Mississippi Mills 2024-03-26
Issued for Permit

Owner/Applicant DCR/PHOENIX HOMES Telephone # 723-9227 Plan # 27M-47 Project nameWHITE TAIL RIDGE Civic Address:123 FRANK FISHER CR House model: BIRCHWOOD LOFT C	Bldg. Ht. 8.74 m Lot coverage 10 % Scale 1:250 Sod Area 1969 m ² Asphalt Area 87 m ²	<div><div><div>LOT 140</div><div>SITE/GRADING PLAN</div><div>WHITE TAIL RIDGE PH.IV</div></div></div>
	CHECKED/APPROVED BY: T.L.MAK ENG. REV. FEB.16/24 – CB

**Re: Proposed Single Family Dwelling, 123 Frank Fisher Crescent, Lot # 140 White Tail Ridge, Arnprior,
Kollaard Associates File # 240020**

With regard to structural issues only, Kollaard Associates has reviewed the following drawings:

LEFT SIDE ELEV C

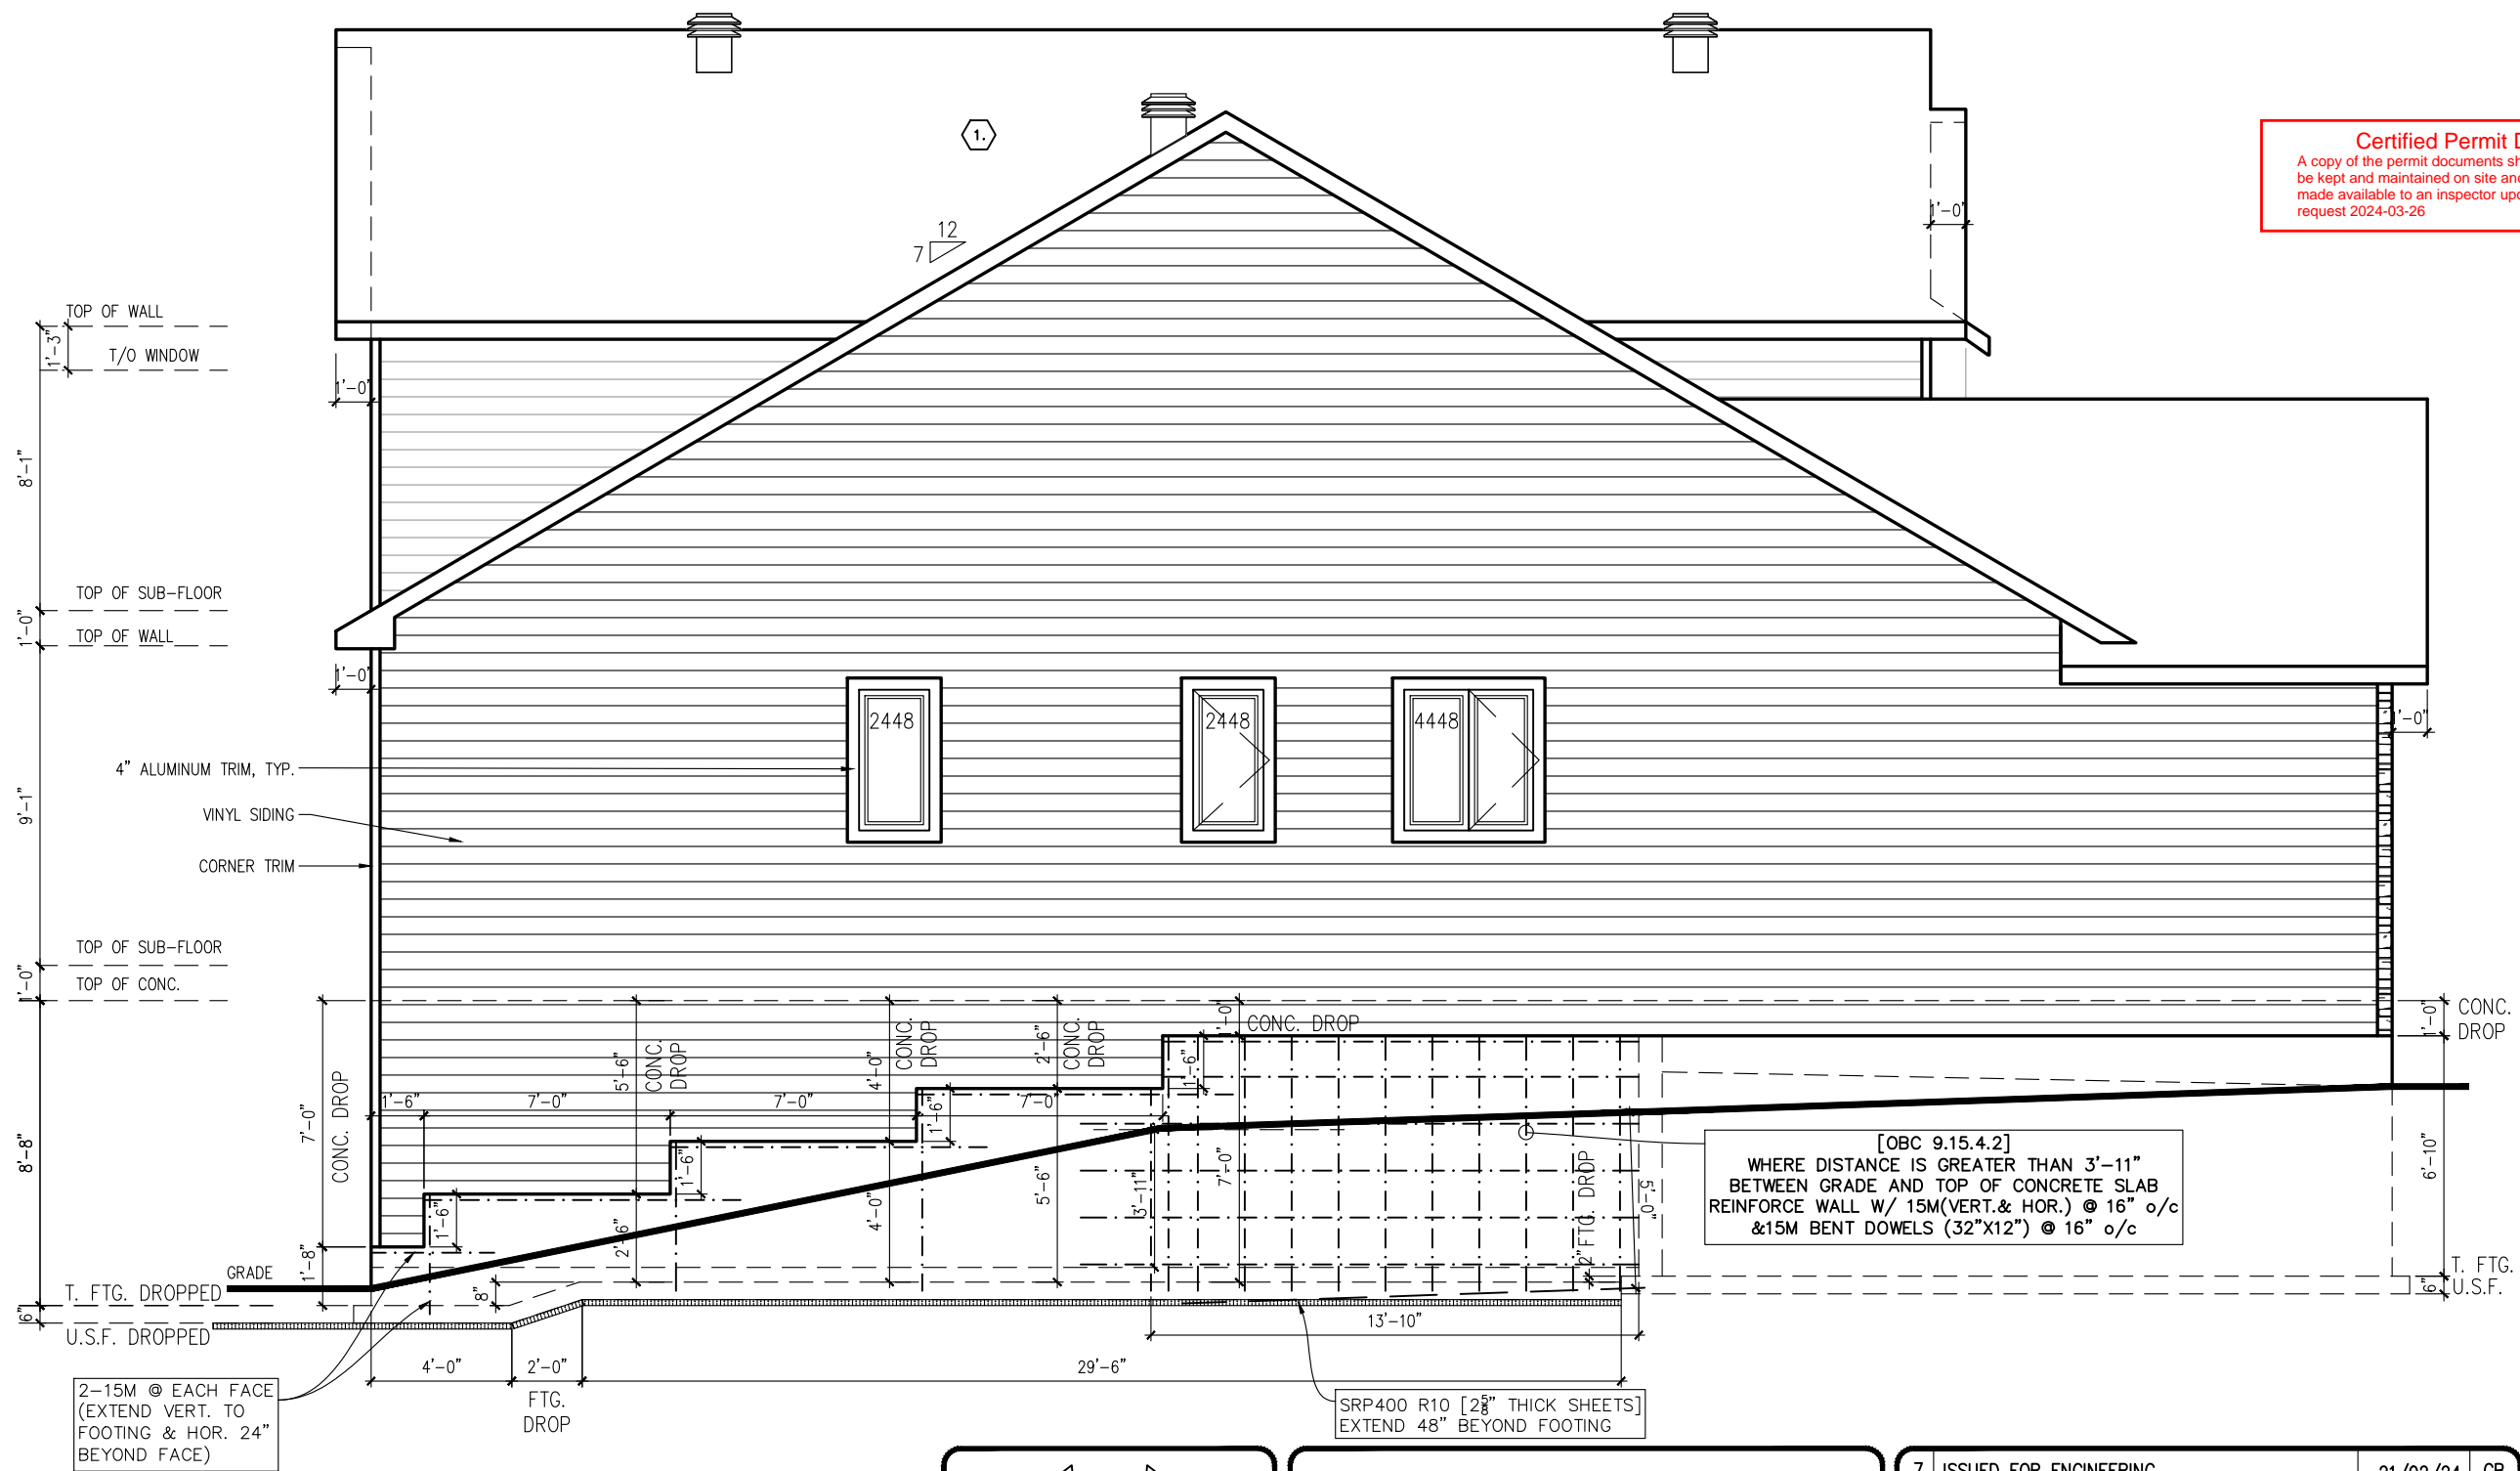
12. Where the grade difference between the basement slab and the exterior finished grade exceeds 3'-11" along the sides, the proposed foundation reinforcement noted on Phoenix Homes Pages # 6C and 7C are adequate to withstand the lateral earth pressures.

SECTION ELEVATION C

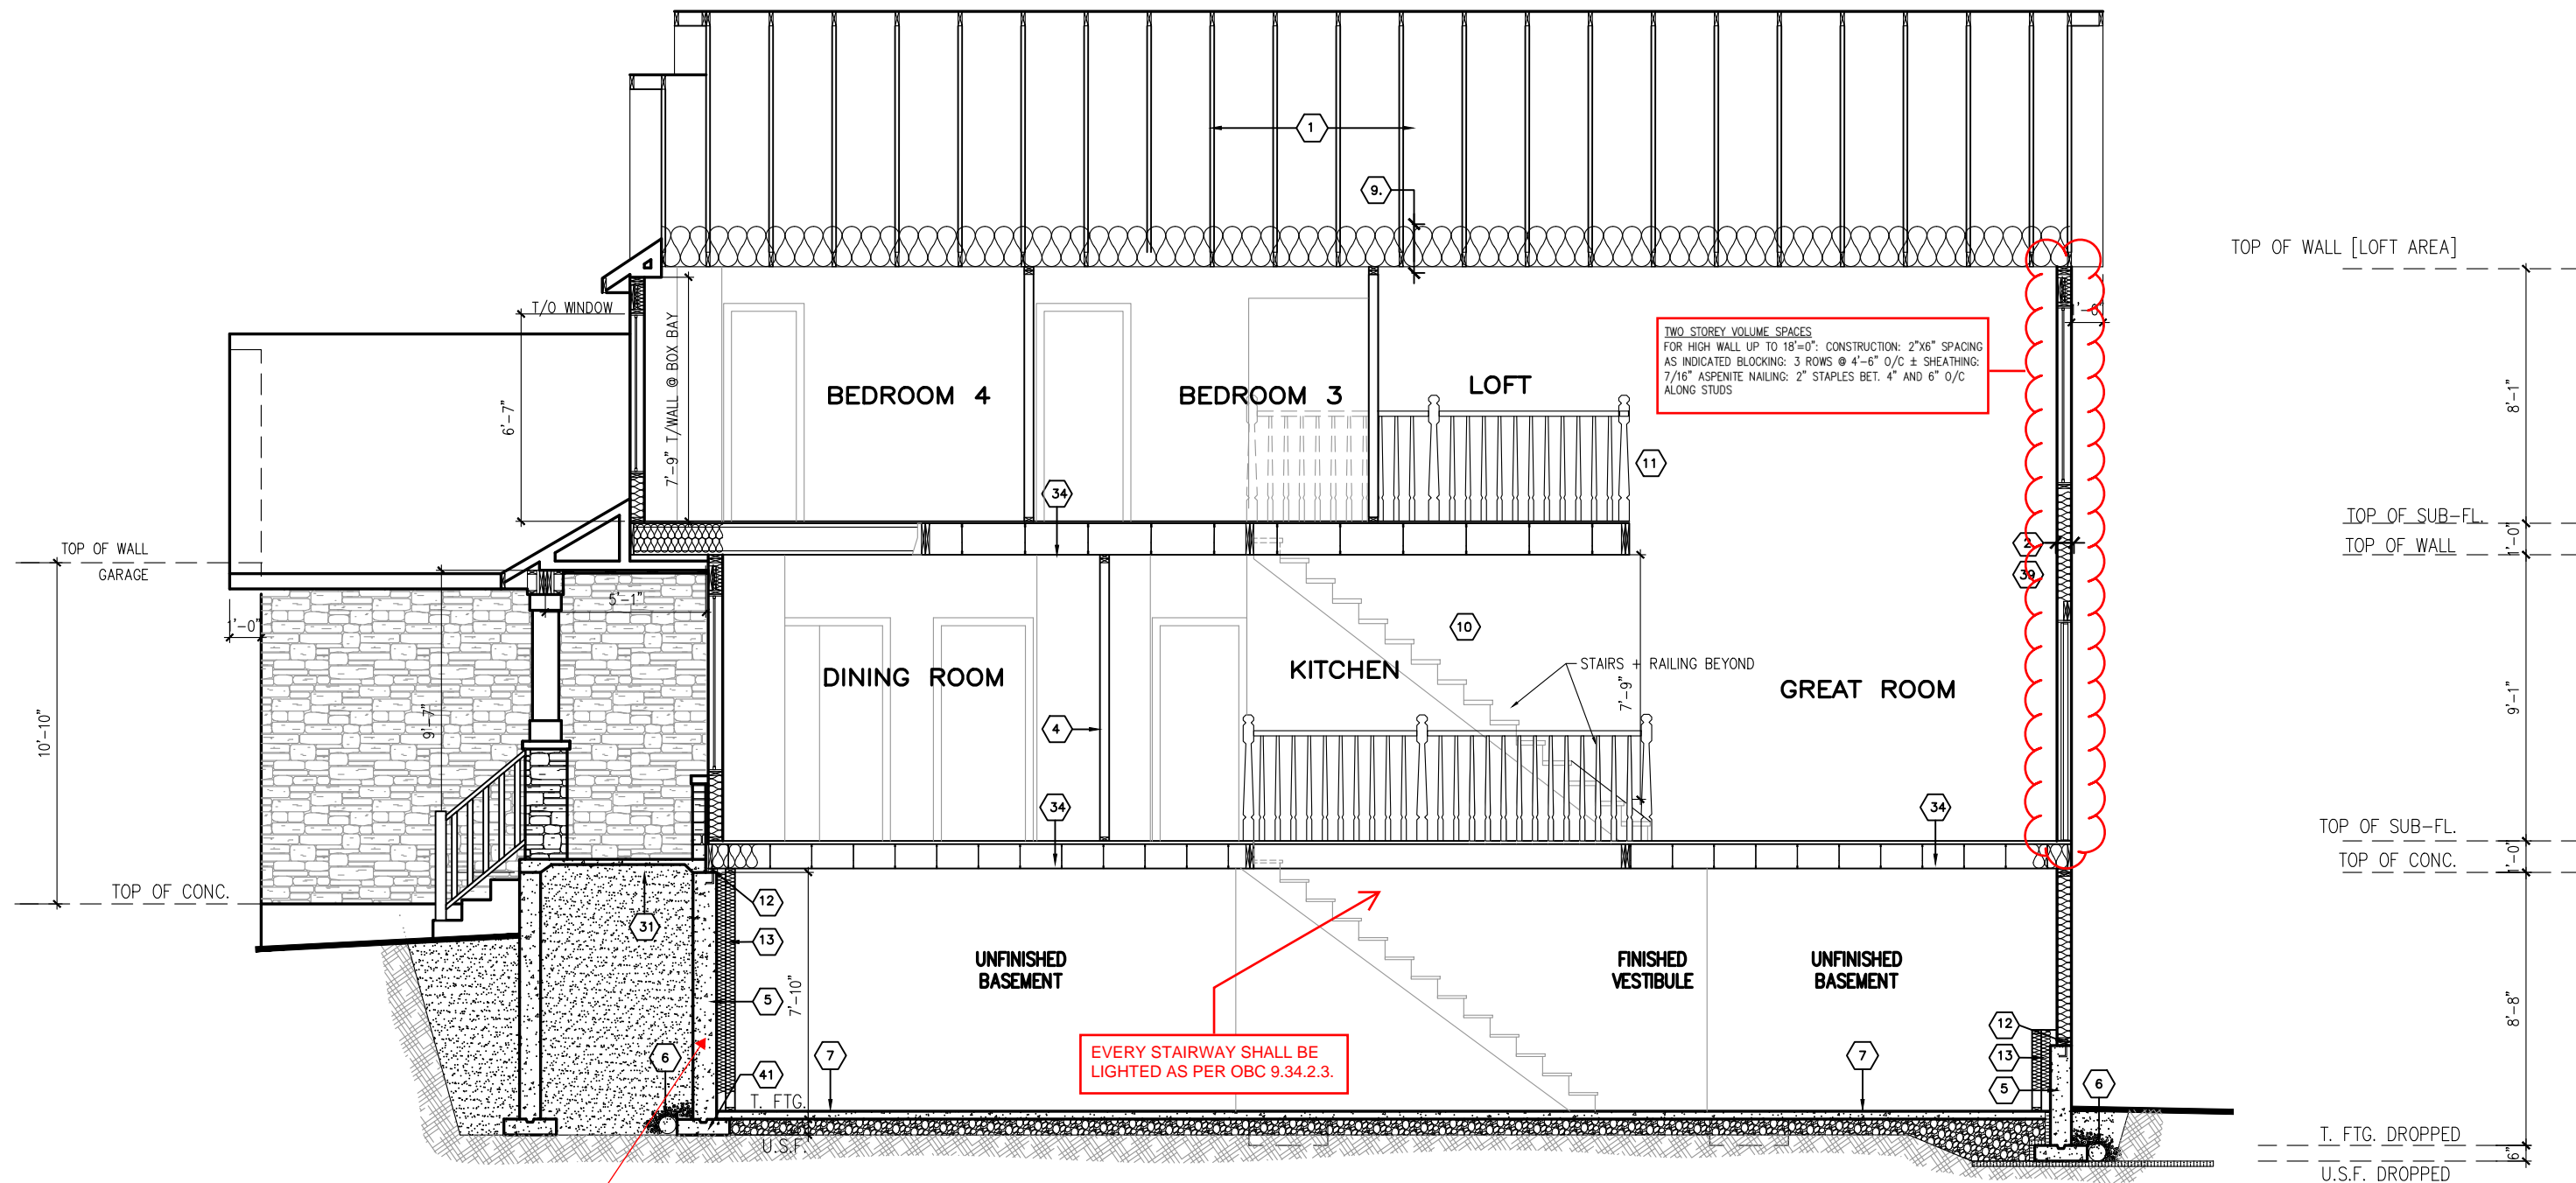
Wall height OK See item 10 Kollaard
Engineering letter of Feb. 21, 2024
